# Two proposals for priority based PLCA

**Sungkwon Park**

**Inyong Jung, Jinhwa Yun, Dongok Kim / Hyundai Motor Company**

Figure 148-5 PLCA DATA state Diagram

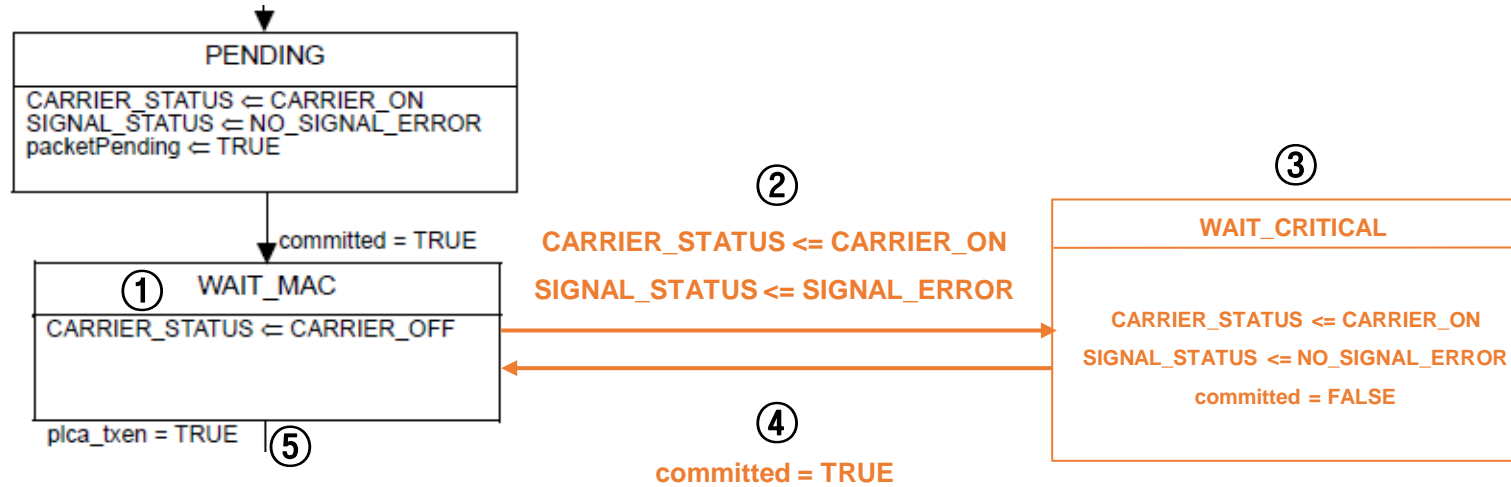
## 3. Changes to PLCA DATA state Diagram

- Figure 148-5 shows the state diagram of the operation of the node with the transmission opportunity.

1) **WAIT\_MAC** = IDLE time

- 2) When an ALARM signal is received, the **CARRIER\_STATUS** is in the **CARRIER\_ON** state to transmit CRITICAL DATA and the **SIGNAL\_STATUS** becomes the **SIGNAL\_ERROR** state to enter **WAIT\_CRITICAL**.
- 3) After entering the **WAIT\_CRITICAL** state (CRITICAL DATA transmission), the state of the node having the transmission opportunity recognizes the transmission of the CRITICAL DATA through **CARRIER\_STATUS <= CARRIER\_ON** and waits (**committed = FALSE**).
- 4) After CRITICAL DATA transmission is completed, the waiting node acquires the transmission opportunity again (**committed = TRUE**).
- 5) The waiting node have an IDLE time and start to transmit DATA.

#### Clause 148.4.5.1 PLCA Data State Diagram

But when an ALARM signal is received, the CARRIER\_STATUS is in the CARRIER\_ON state to transmit CRITICAL DATA and the signal status becomes the SIGNAL\_ERROR state to enter WAIT\_CRITICAL. After entering the WAIT\_CRITICAL state (CRITICAL DATA transmission), the state of the node having the transmission opportunity recognizes the transmission of the CRITICAL DATA through  $CARRIER\_STATUS \leq CARRIER\_ON$  and waits (committed = FALSE). After CRITICAL DATA transmission is completed, the waiting node acquires the transmission opportunity again (committed = TRUE). The waiting node have an IDLE time and start to transmit DATA.

Figure 148-4 PLCA CONTROL state Diagram

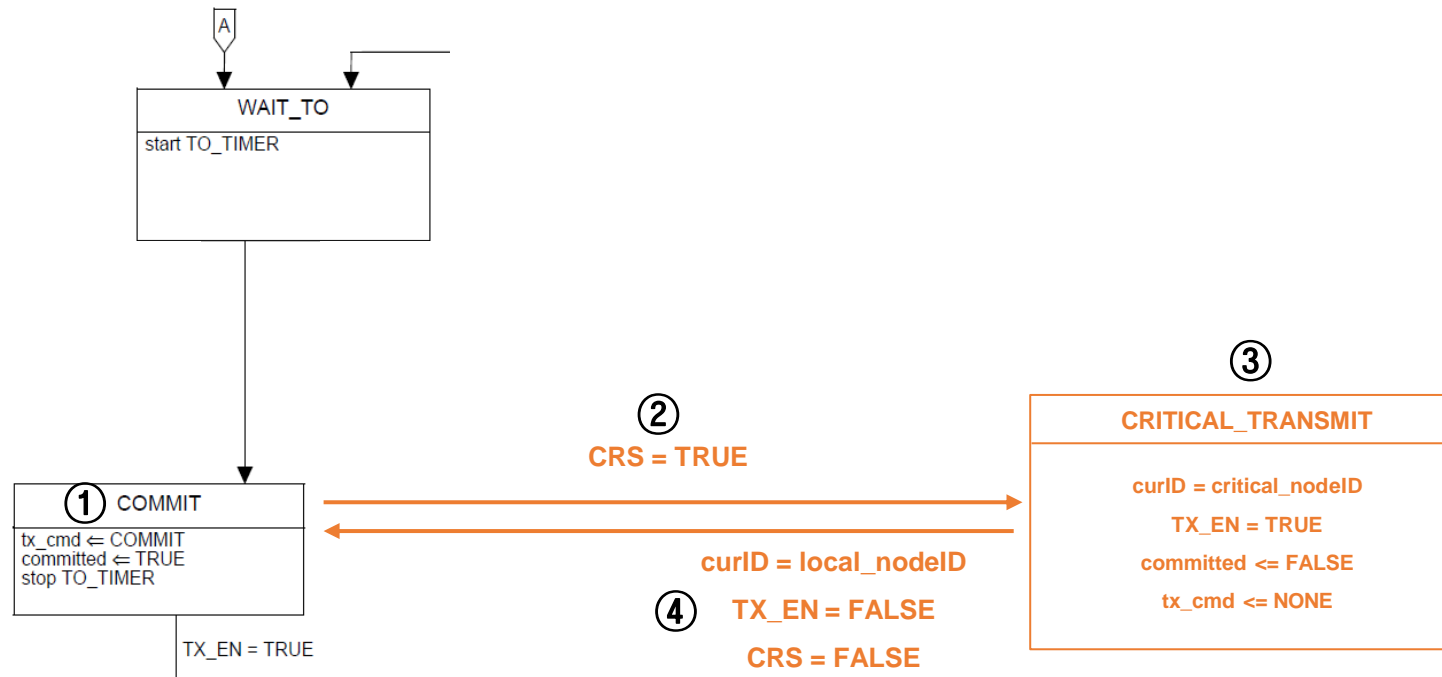
## 3. Changes to PLCA CONTROL state Diagram

- 1) It is IDLE time of a low priority node.
- 2) An ALARM signal has been detected (**CRS = TRUE**).

- 3) The transmission opportunity is passed to the node that generated the ALARM signal (`curID = critical_nodeID`). The node with the previous transmission opportunity stores the transmission sequence number using the `local_nodeID` variable.
- 4) When the transmission of the critical data is completed, the transmission opportunity is returned to the original node (`curID = local_nodeID`) and the regular PLCA transmission cycle is continued.

#### Clause 148.4.5.1 PLCA Control State Diagram

When an ALARM signal has been detected ( $CRS = TRUE$ ), the transmission opportunity is passed to the node that generated the alarm signal ( $curID = critical\_nodeID$ ). The node with the previous transmission opportunity stores the transmission sequence number using the  $local\_nodeID$  variable. When the transmission of the critical data is completed, the transmission opportunity is returned to the original node ( $curID = local\_nodeID$ ) and the regular PLCA transmission cycle continues.
